U. S. NUCLEAR REGULATORY COMMISSION

REQUEST FOR ADDITIONAL INFORMATION (RAI) QUESTIONS FOR

TOPICAL REPORT (TR) WCAP-17642-P, REVISION 0, AND WCAP-17642-NP, REVISION 0,

"WESTINGHOUSE PERFORMANCE ANALYSIS AND DESIGN MODEL (PAD5)" - SET 2

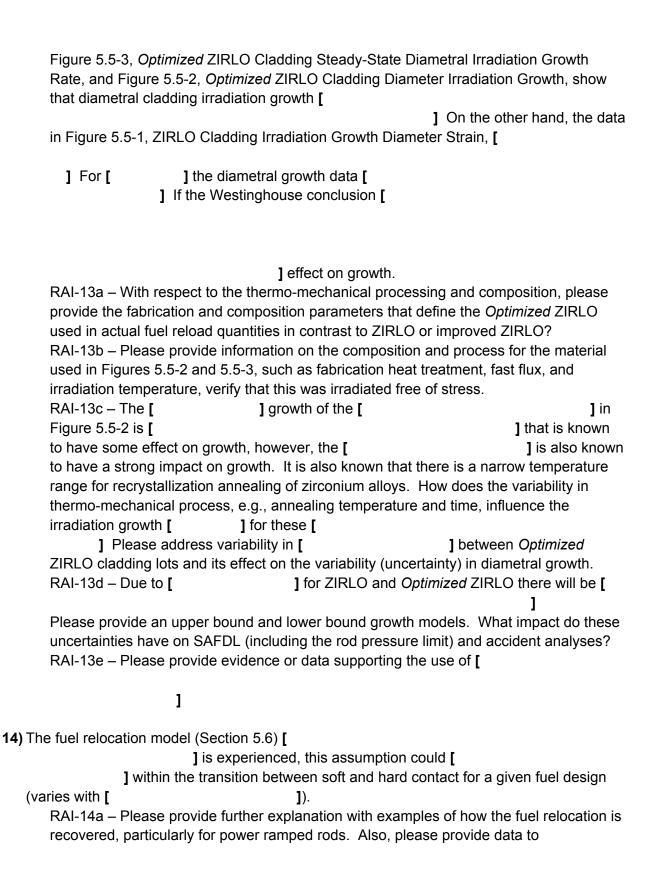
RAI-12a – Please identify the lattice designs of these data in Tables A.2.2-3 and A.2.5-2, and on Figure A.2.5-3 identify those rods that are IFBA.

RAI-12b – It is obvious that [please discuss the possible []
